Title - Sujet Interpretation Center-Mary's Point,	
Solicitation No. - N° de l'invitation EC015-180296/A	Amendment No. - N° modif. 001
Client Reference No. - N° de référence du client EC015-180296	Date 2017-07-05
GETS Reference No. - N° de référence de SEAG PW-\$PWB-100-4143	
File No. - N° de dossier PWB-7-40025 (100)	CCC No./N° CCC - FMS No./N° VME
Solicitation Closes - L'invitation prend fin at - à 02:00 PM on - le 2017-07-13	
Time Zone Fuseau horaire Atlantic Daylight Saving Time ADT	
F.O.B. - F.A.B. Plant-Usine: <input type="checkbox"/> Destination: <input checked="" type="checkbox"/> Other-Autre: <input type="checkbox"/>	
Address Enquiries to: - Adresser toutes questions à: MacDonald, Anne (PWB) D.	Buyer Id - Id de l'acheteur pwb100
Telephone No. - N° de téléphone (902) 626-4949 ()	FAX No. - N° de FAX (506) 636-4376
Destination - of Goods, Services, and Construction: Destination - des biens, services et construction:

Addendum # 1
EC015-180296/A
July 5, 2017

Interpretive Centre, Shepody National Wildlife Area
 414 Mary's Point, Harvey
 New Brunswick
 (EC015-180296/A)
 Site Visit: June 28, 2017 @ 10:00

DRAWING SK-1

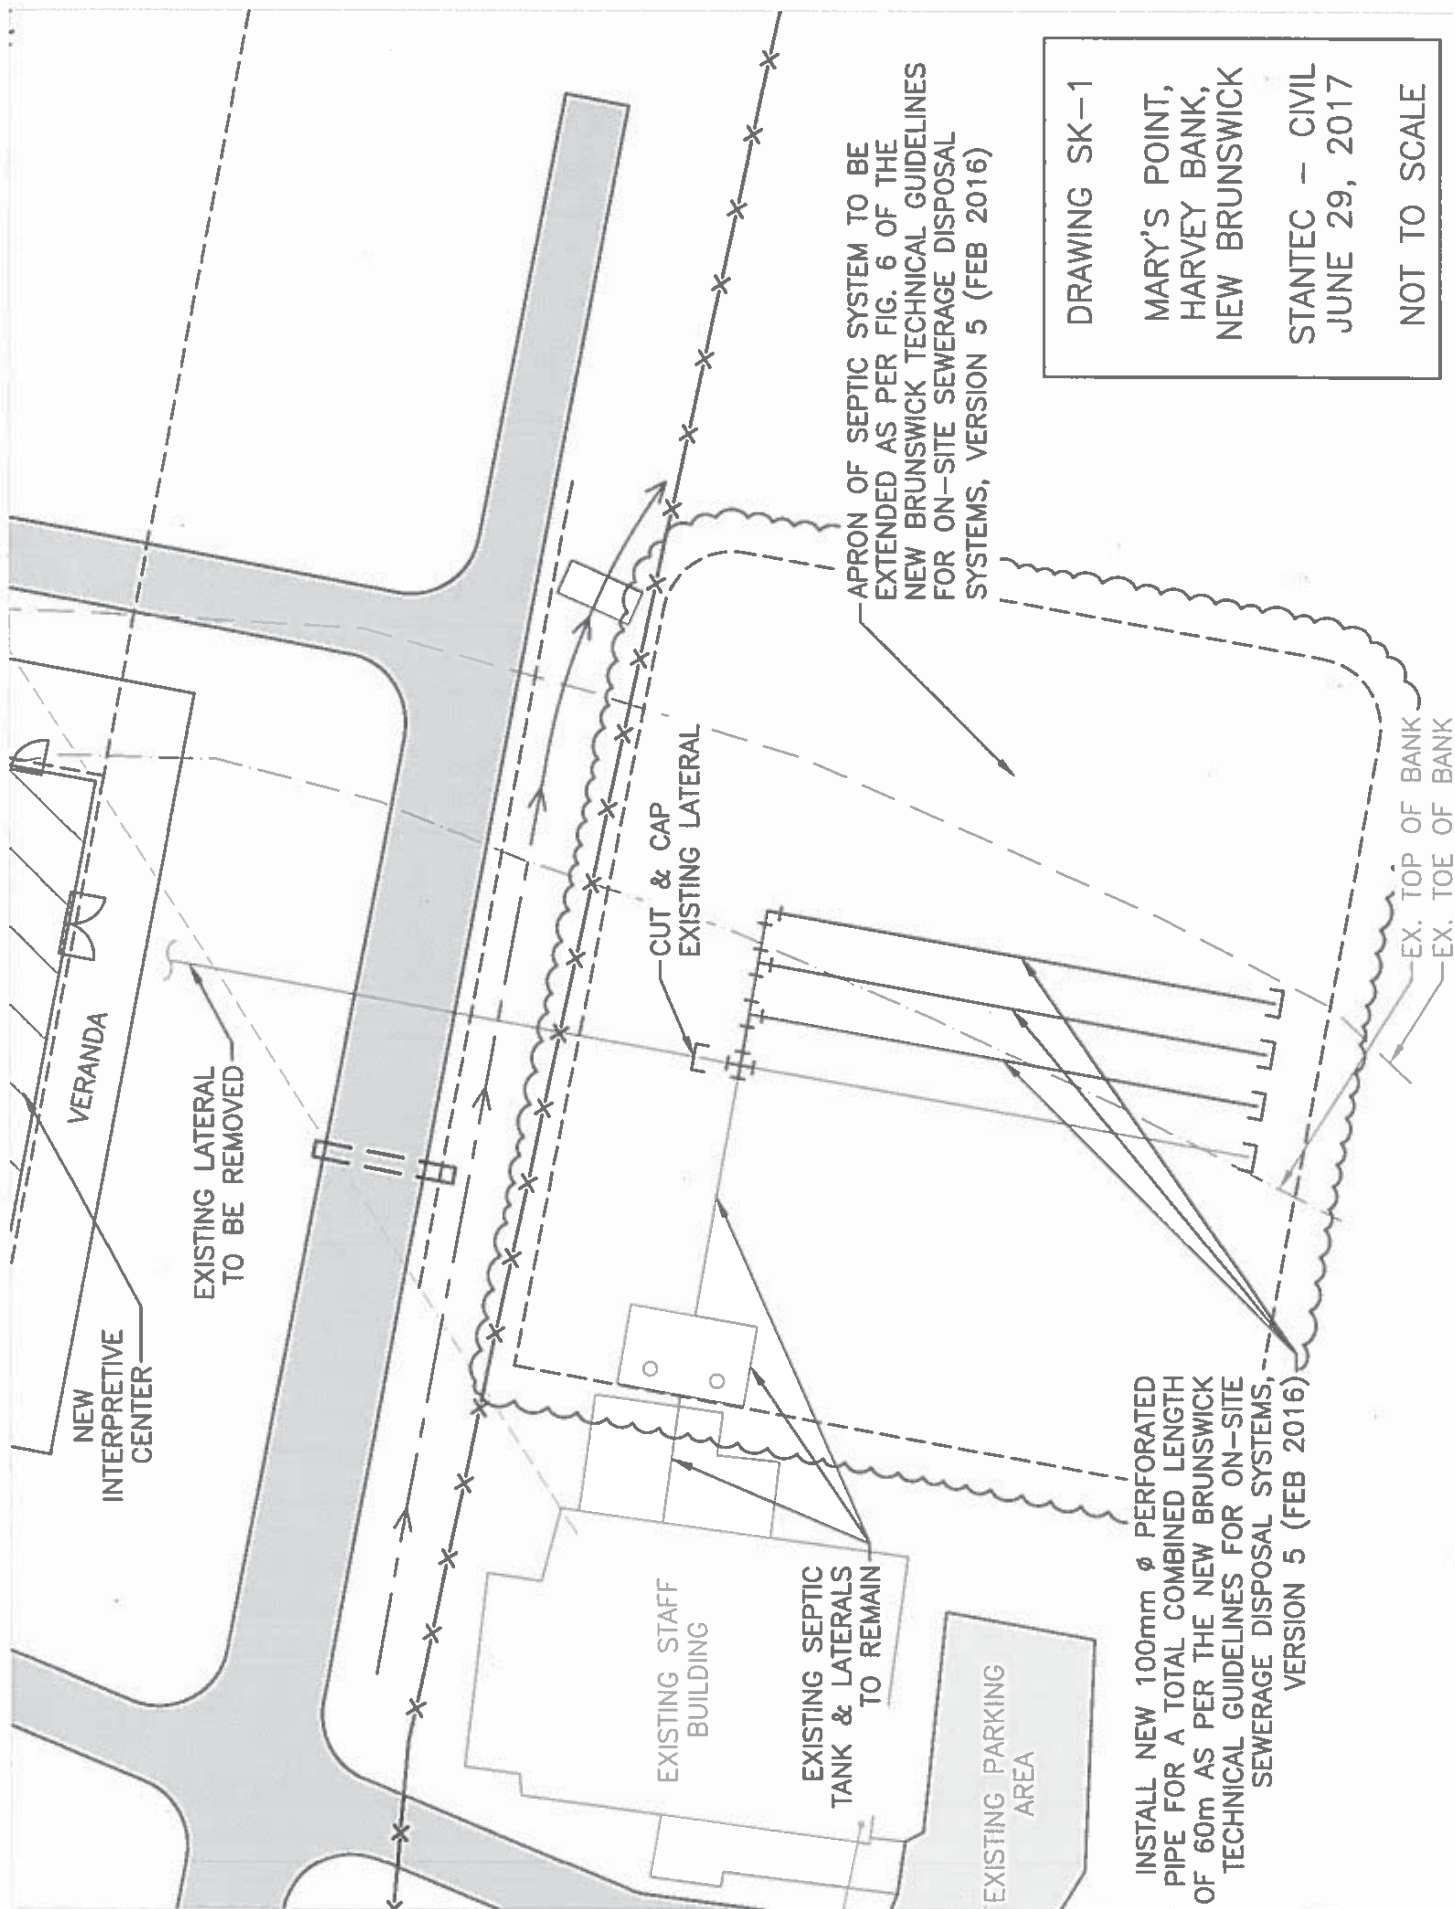
- Item 7 The existing septic system is to be modified to address conflicts with the proposed building. The existing 100mm diameter PVC perforated pipe is to be cut and capped at the limit of construction as shown on the attached Drawing SK-1. The Contractor is to confirm the location of the existing septic system and perforated pipe in the field prior to construction. New 100mm diameter PVC perforated pipe is to be installed and connected to the existing distribution system for a total perforated pipe length of 60m, maximum 15m absorption trench lengths each, offset 1.5m centerline to centerline of each trench, and installed as per the *New Brunswick Technical Guidelines for On-site Sewage Disposal Systems* by a certified Contractor. Refer to Figure 6 of the *New Brunswick Technical Guidelines for On-site Sewage Disposal Systems*. Modification of the existing septic system must be approved by the Department of Public Safety prior to construction.
